Focused Corrective Measures Study/Feasibility Study for D-Area Ash Basin Wetlands (NBN) in Support of the Savannah River Floodplain Swamp Integrator Operable Unit (U)

SRNS-RP-2024-01034

Revision 1 Redline ~~0~~

May 2025~~October 2024~~

Figure 5. D-Area Ash Basin Wetlands Sampling Locations

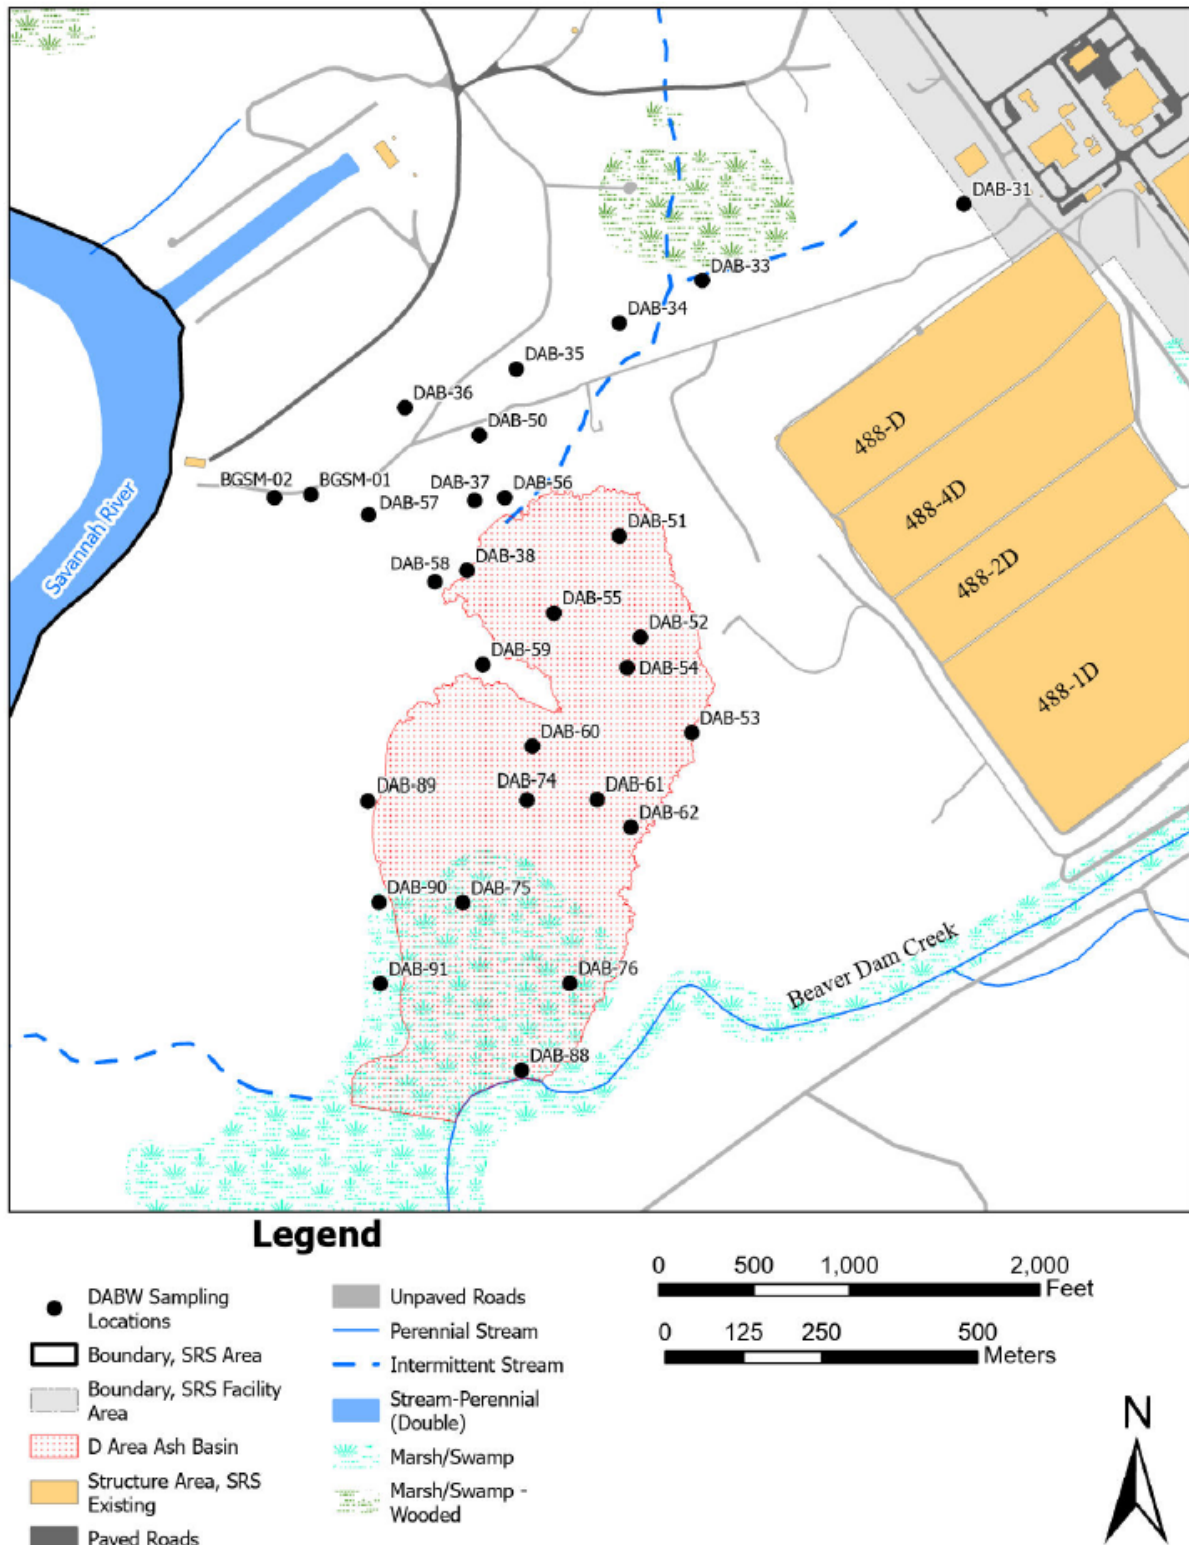
Figure 5 shows the sampling locations ~~associated with~~ used to support the DABW FCMS/FS.
